ADDENDUM #3

THE WICHITA AIRPORT AUTHORITY
 COLONEL JAMES JABARA AIRPORT

FENCE DETAILS

SANITARY SEWER AND WATER DISTRIBUTION SYSTEM
 SOUTHWEST AREA SITE DEVELOPMENT IMPROVEMENTS

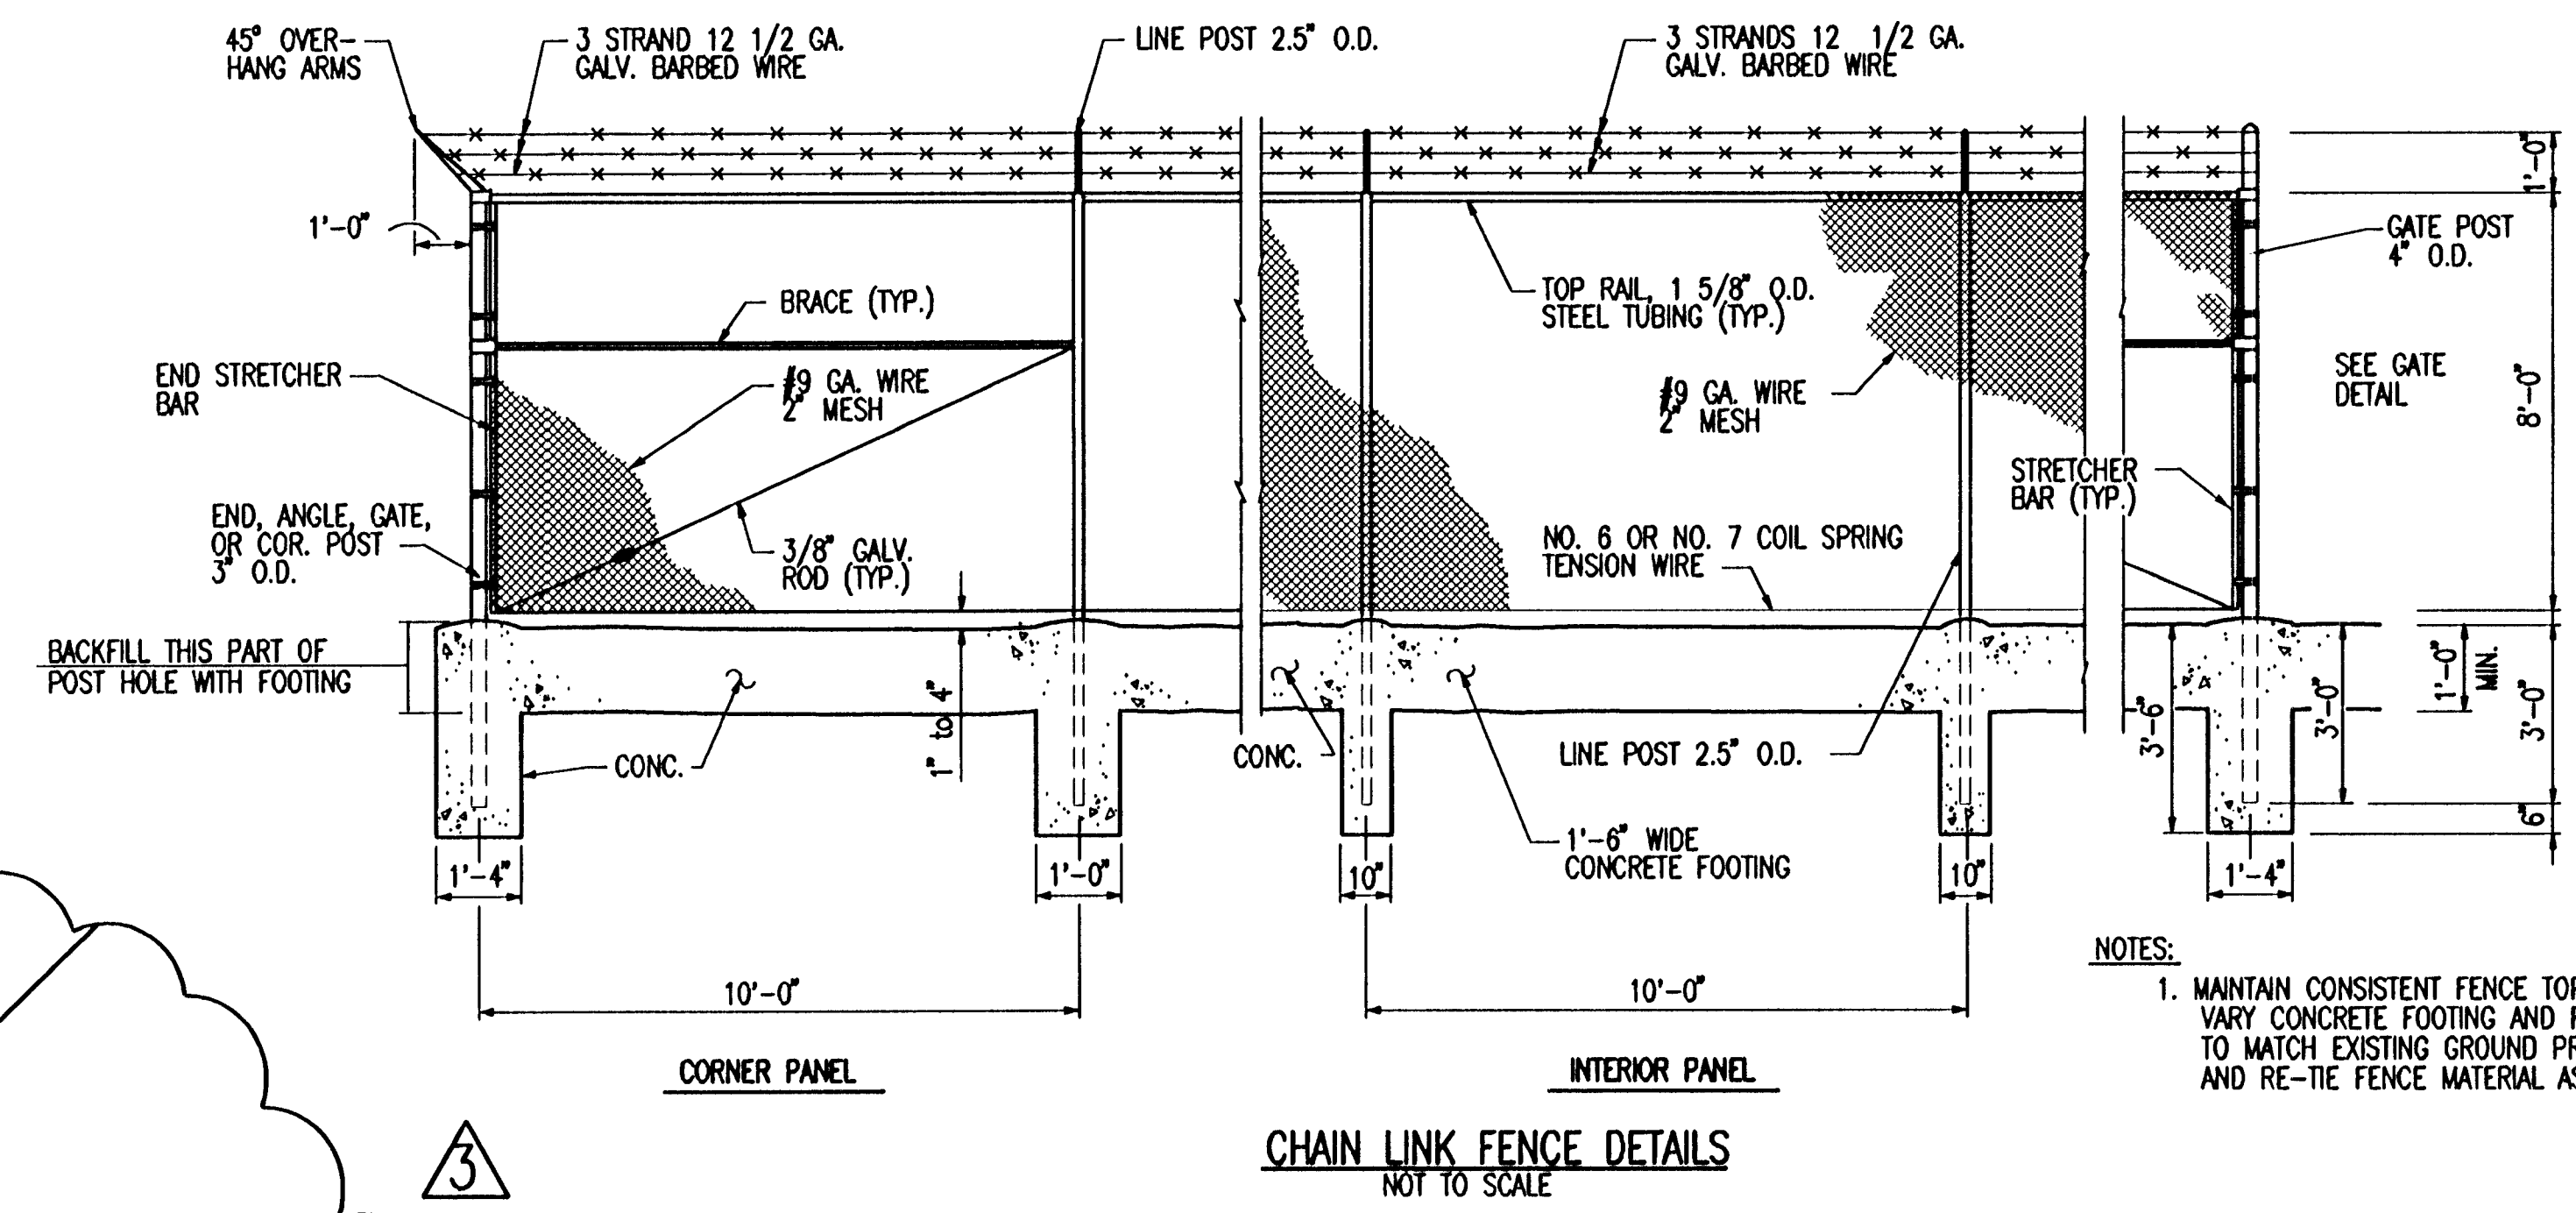
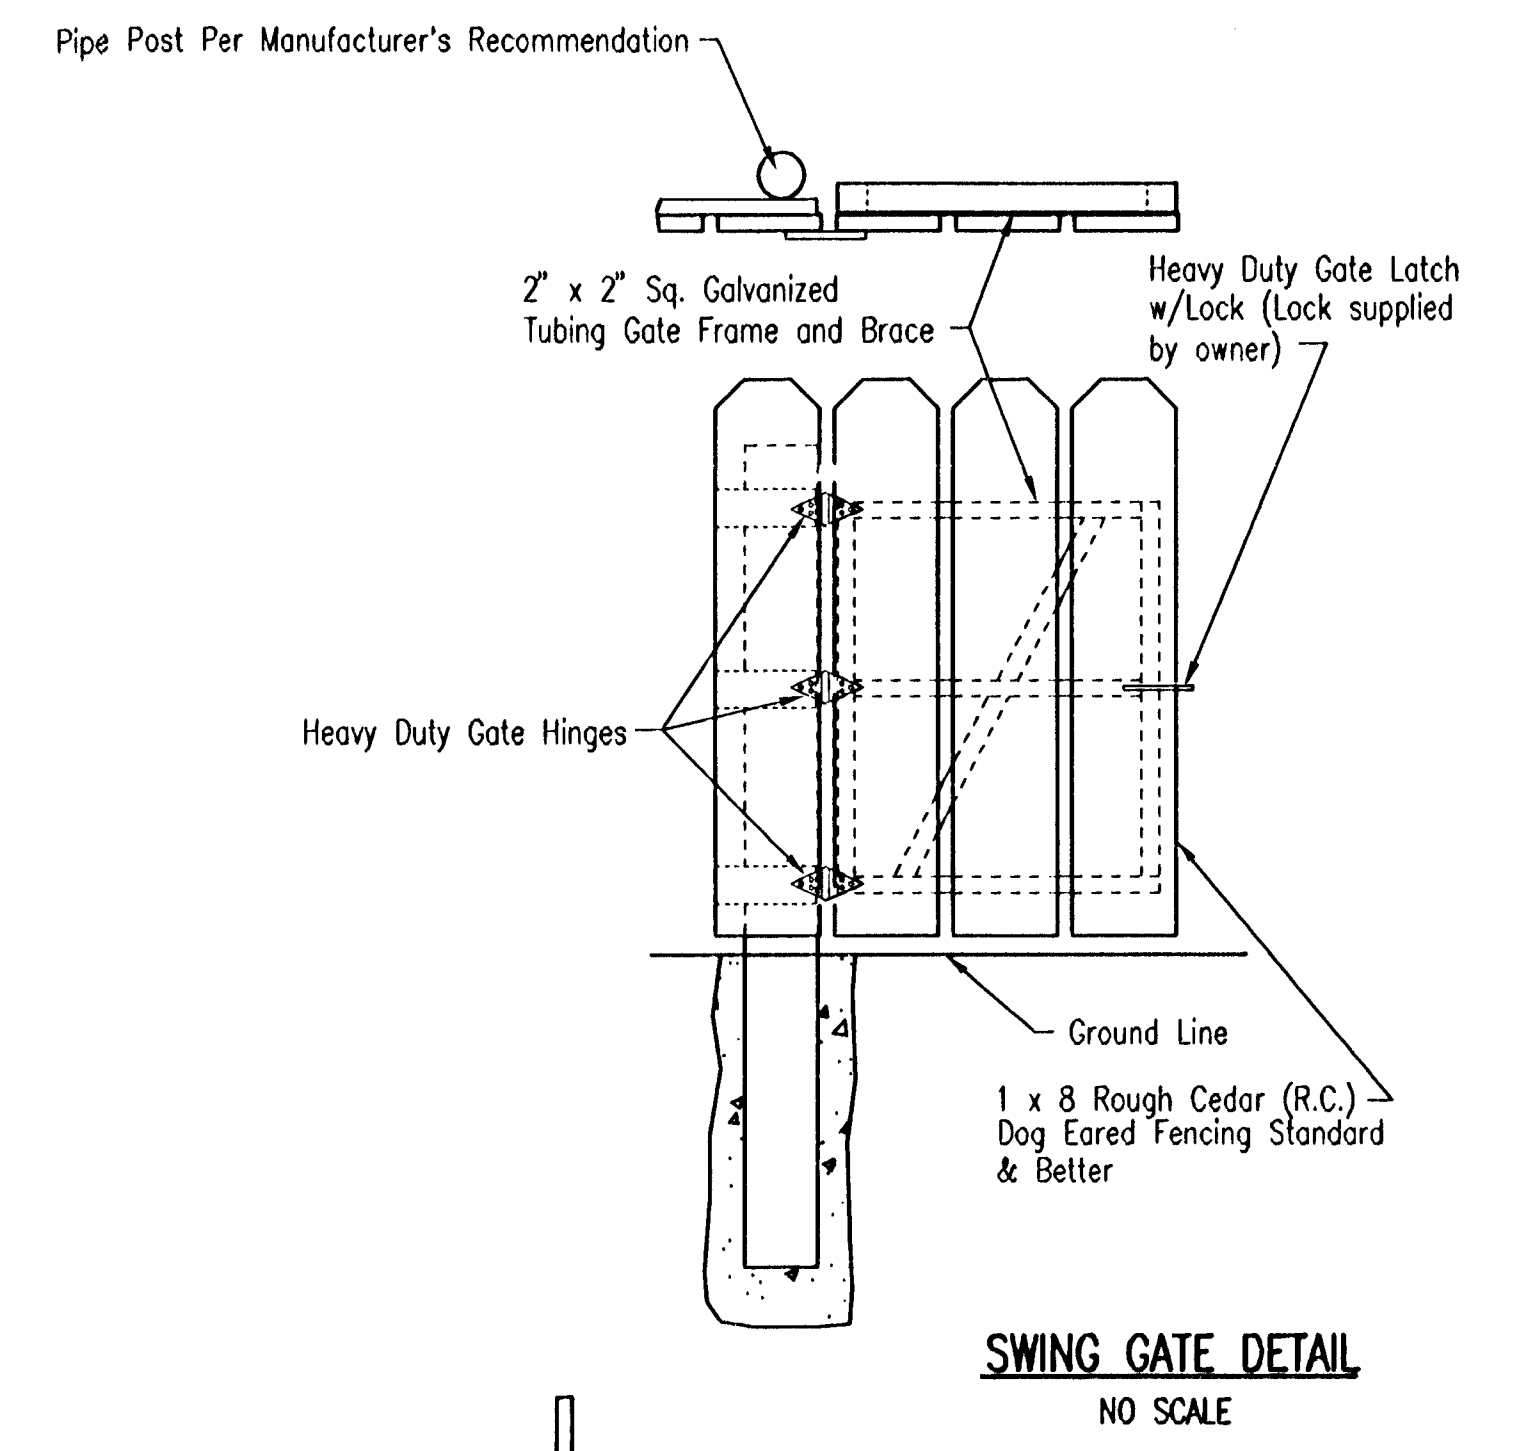
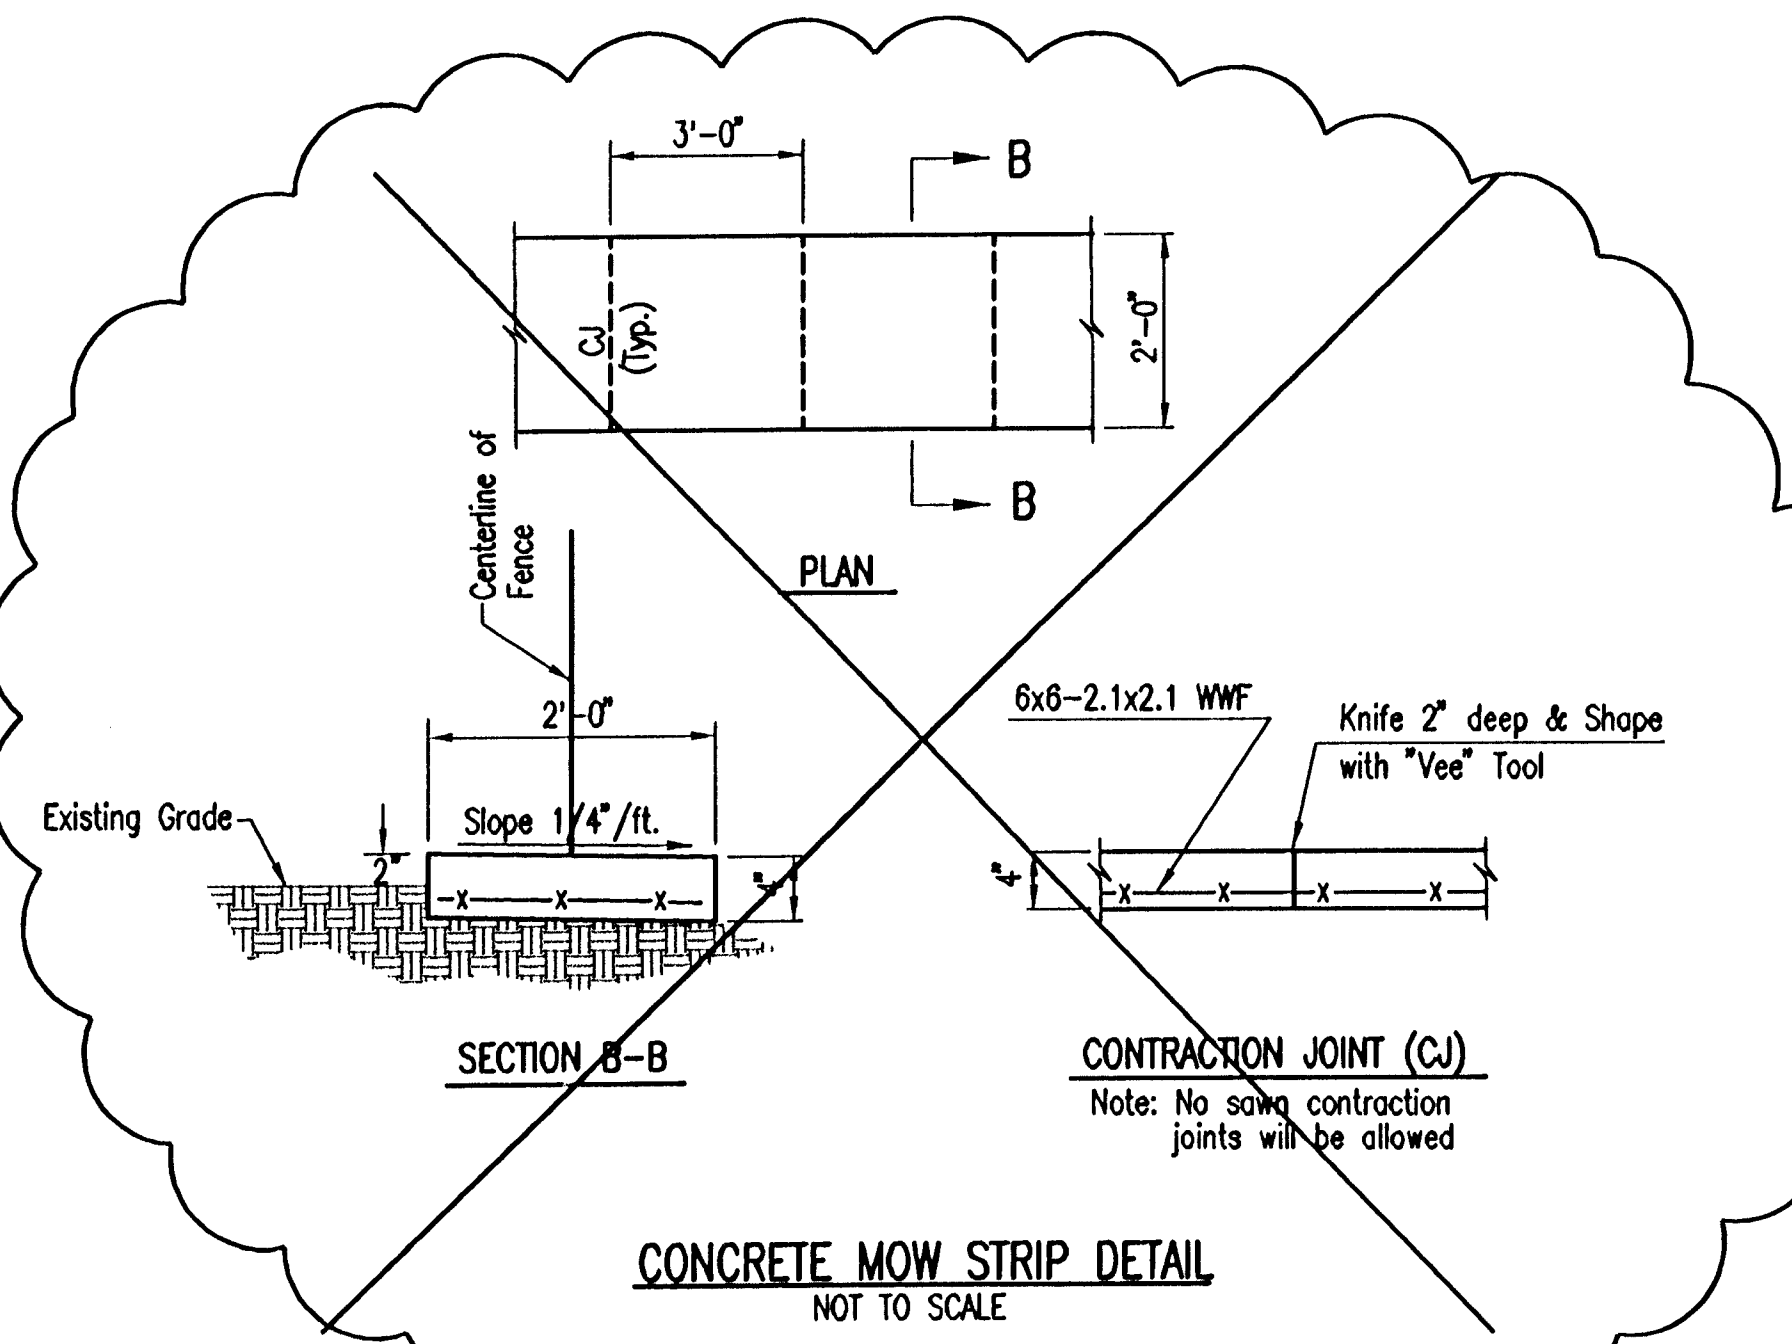
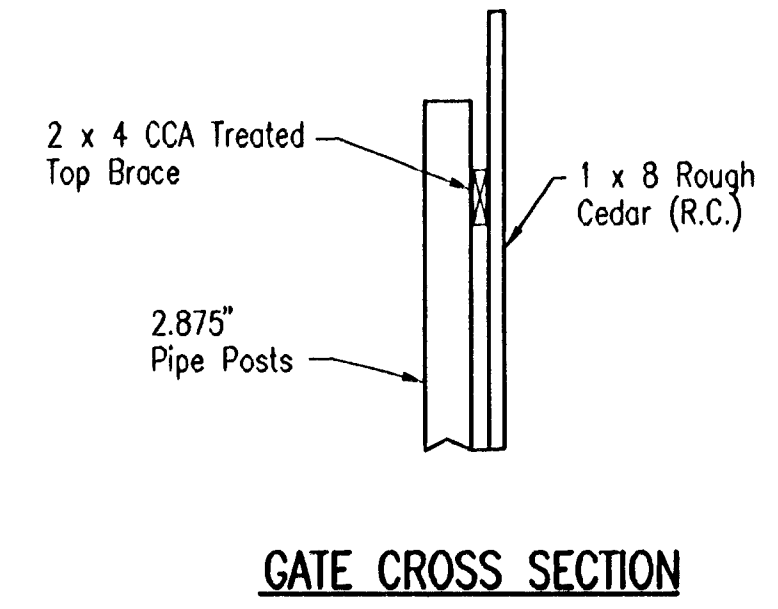
- ADD. #3**
ITEM NO. 6 SHEET CF1.1 - FENCE DETAILS
- A. DELETE CONCRETE MOW STRIP DETAIL. CONCRETE MOW STRIP WILL NOT BE REQUIRED ON TEMPORARY FENCE. SEE CHAIN LINK FENCE DETAIL FOR CONCRETE FOOTING ON PERMANENT FENCE.
 - B. CHAIN LINK FENCE DETAILS, ADD THE FOLLOWING NOTE: "TWO (2) NO 5 BARS SHALL BE INSTALLED IN THE CONCRETE FOOTING. THE REBAR SHALL BE SPACED 1'-0" APART AND SHALL BE PLACED ON EITHER SIDE OF THE POSTS".
